NEW CONSTRUCTION OF

UNCW FILM STUDIES

95% PROGRESS REVIEW SET

Mark	Date	Description
1	10-09-19	Addendum No. 2

1 NORTH ELEVATION

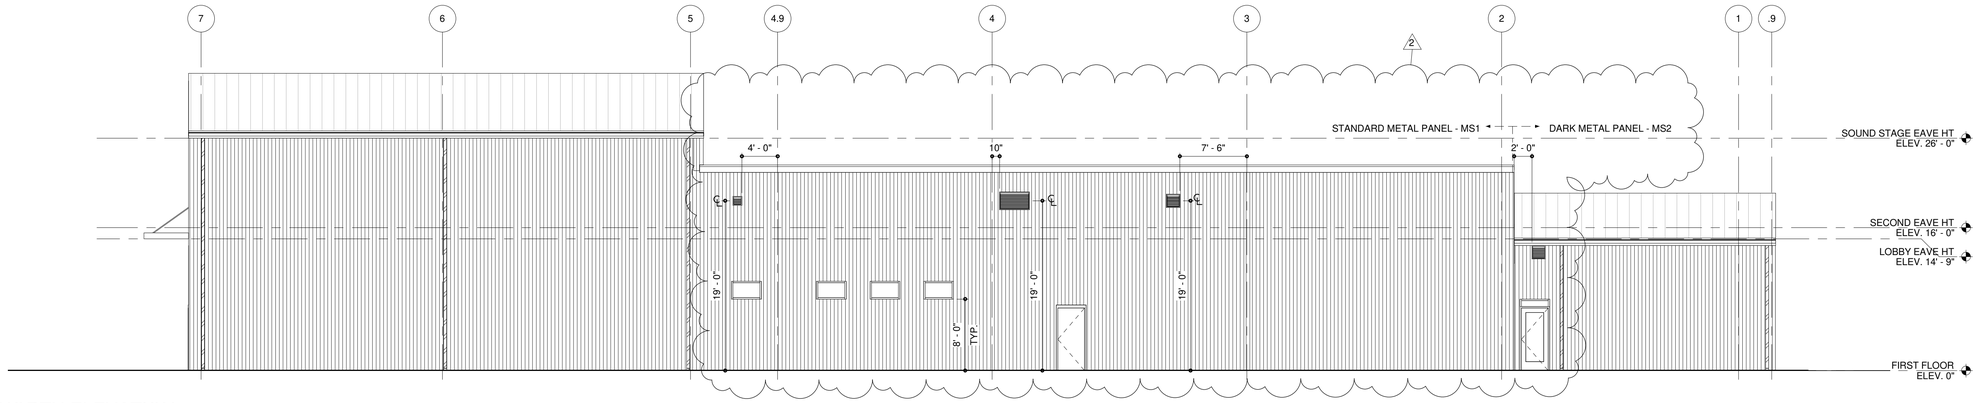
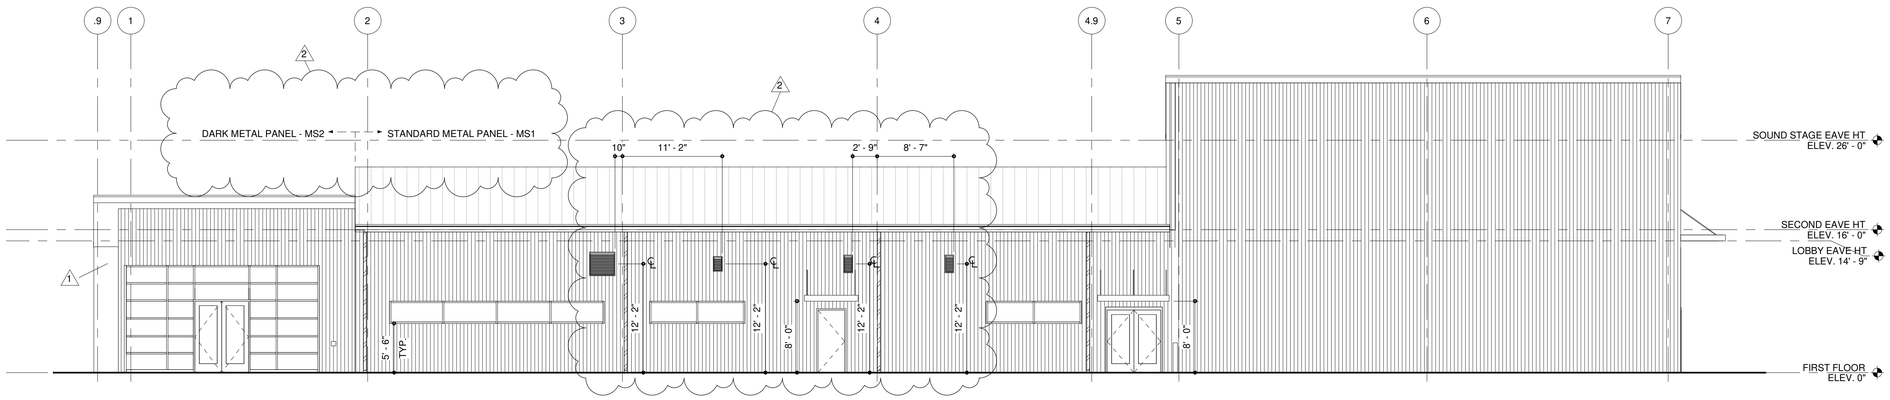
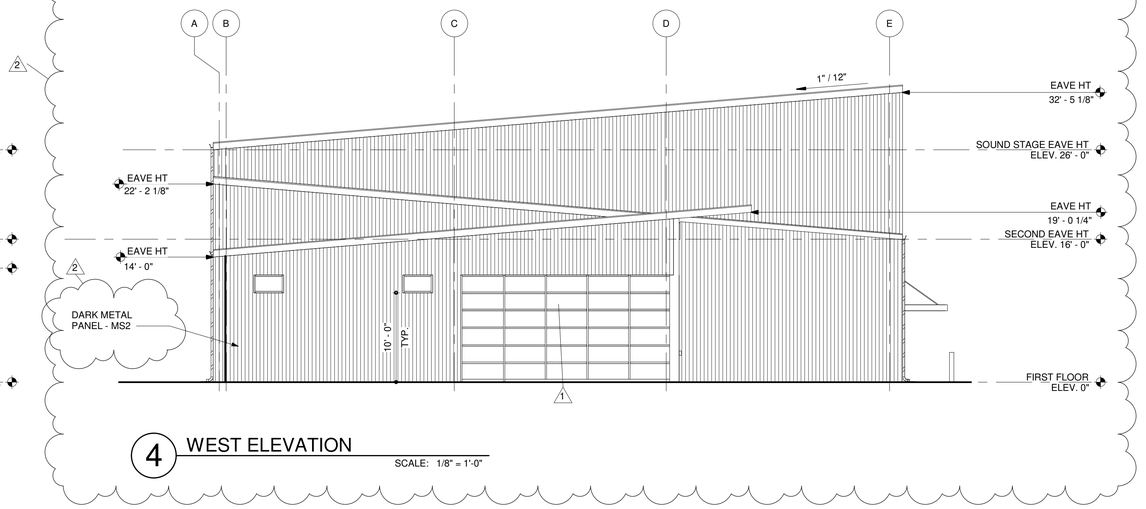
p. The specs call for two wall panels noted as MS1 and MS2. We have not been able to locate either of these referenced in the plans. Please clarify the locations of these panel profiles. **Response: Updated on sheet A201.**

u. What are the heights of the "high" eave points on this project? Elevations only show low eave heights. **Response: Updated on sheet A201.**

w. The wall louver openings shown on the mechanical drawings are not shown on the architectural drawings. Please show on the architectural elevations so metal building subcontractors can see where openings are needed. **Response: Updated on sheet A201.**

4 CINEMA STAGE DETAIL 1

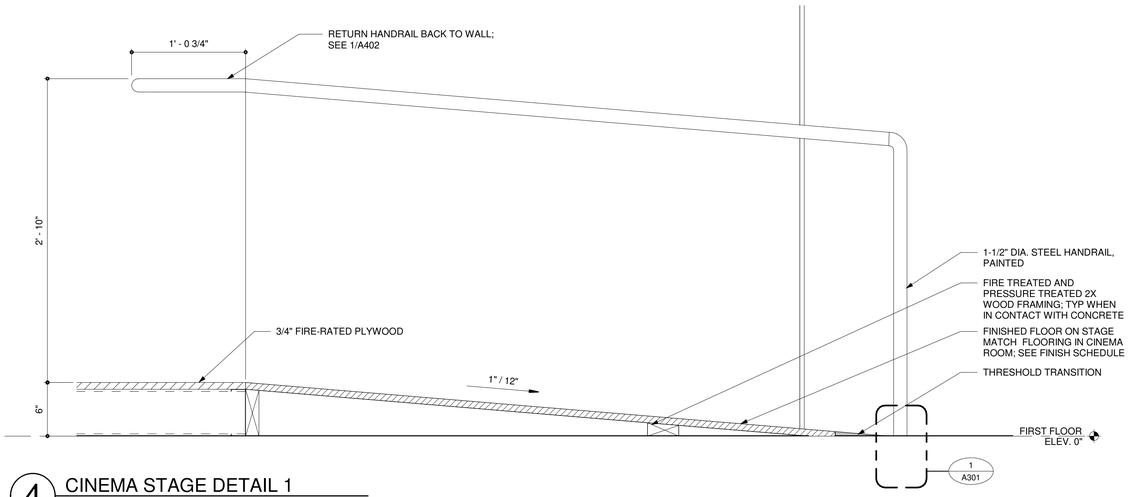
jj. Can you tell me if the stair detail shown for Alternate Bid Cinema A301 detail #2 Stair Nose detail will go from one side to the other on each seating level, or should it only be where people would exit seating? **Response: only at the stair widths, which would be 48" x 2.**

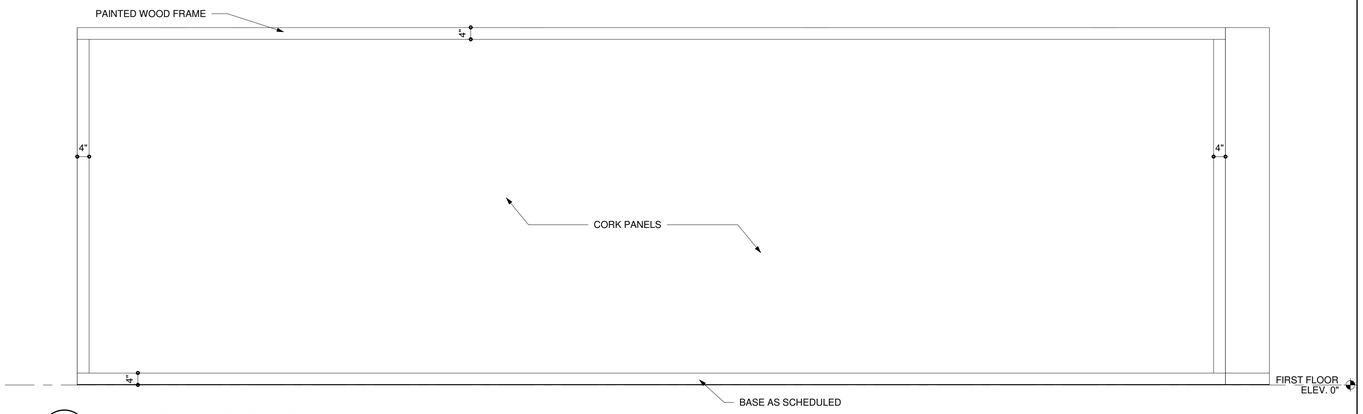
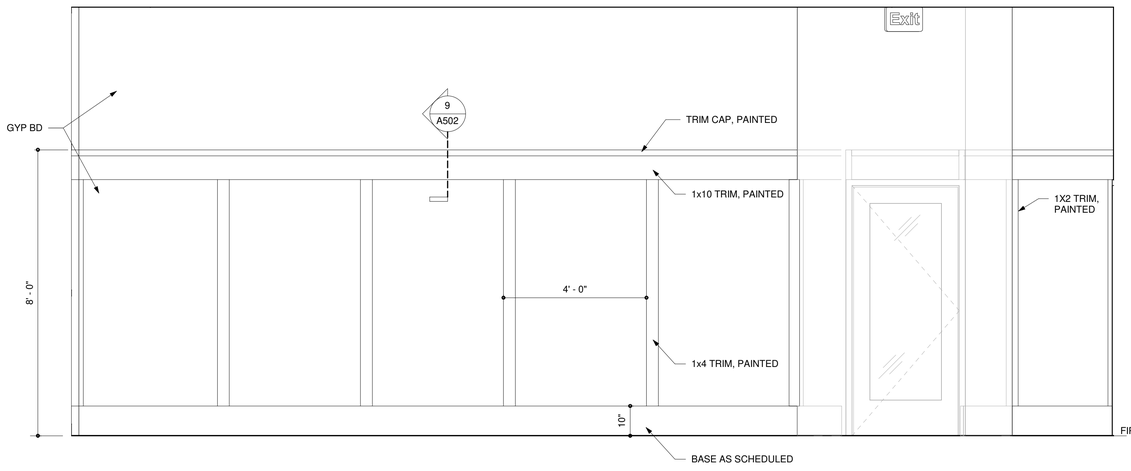
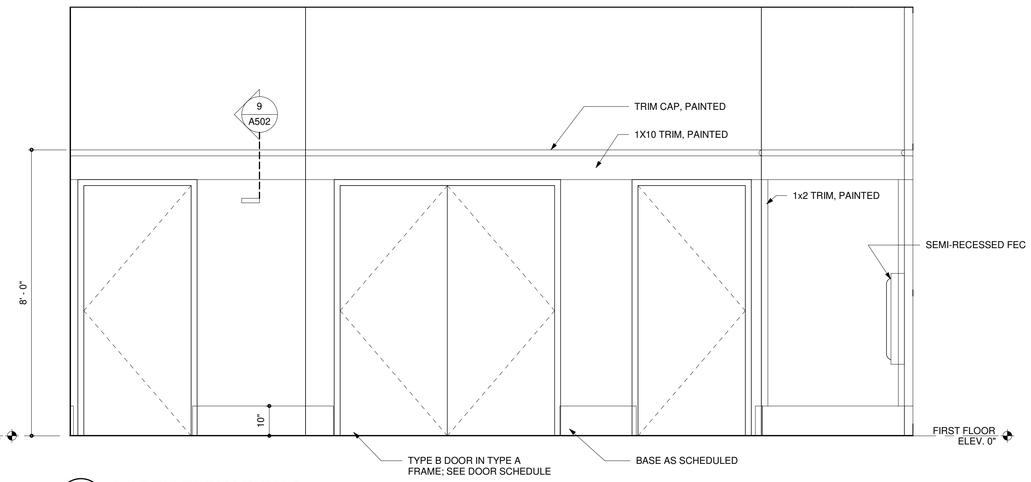
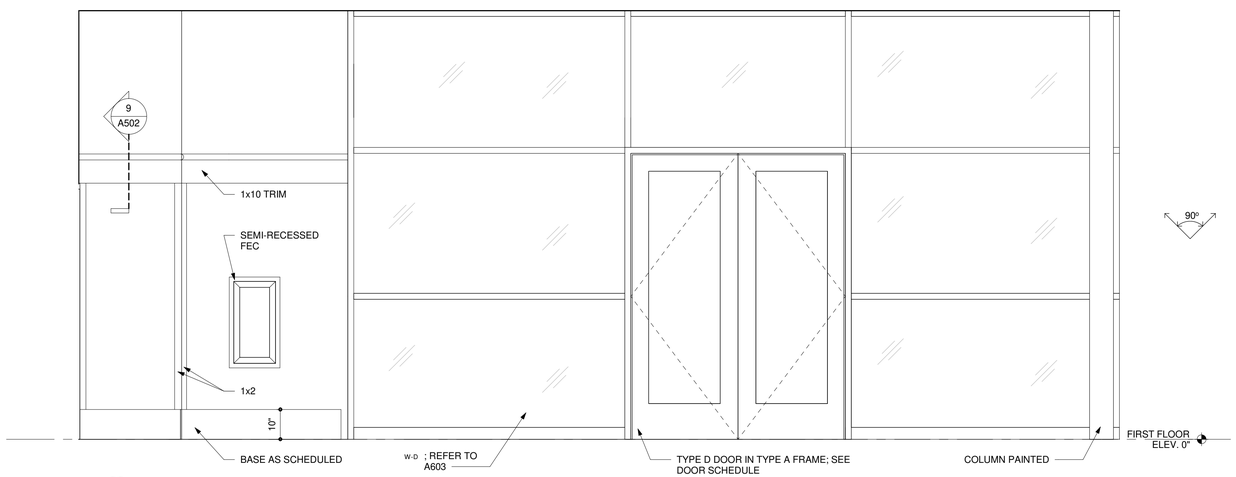
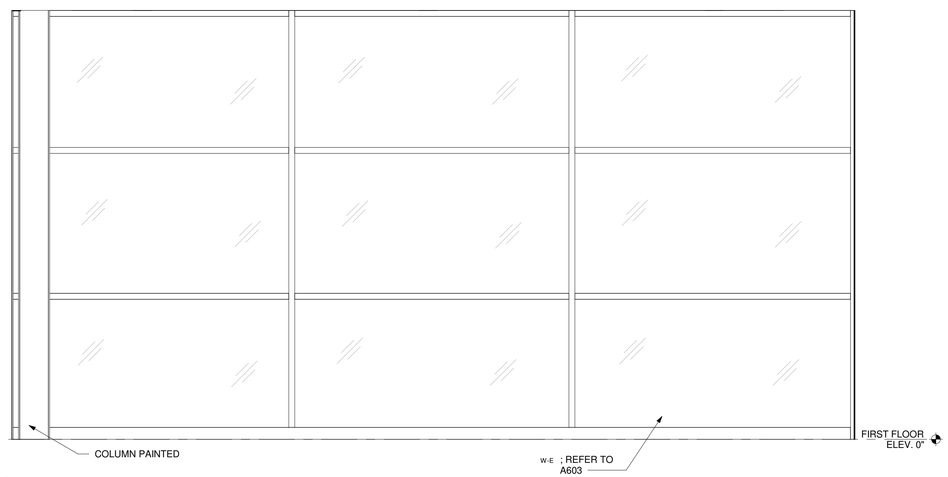
l. The finish schedule shows the wet walls in both bathrooms to receive the 6x6 ceramic glazed tile. However, the elevation drawings on page A401 drawing #5 "sink
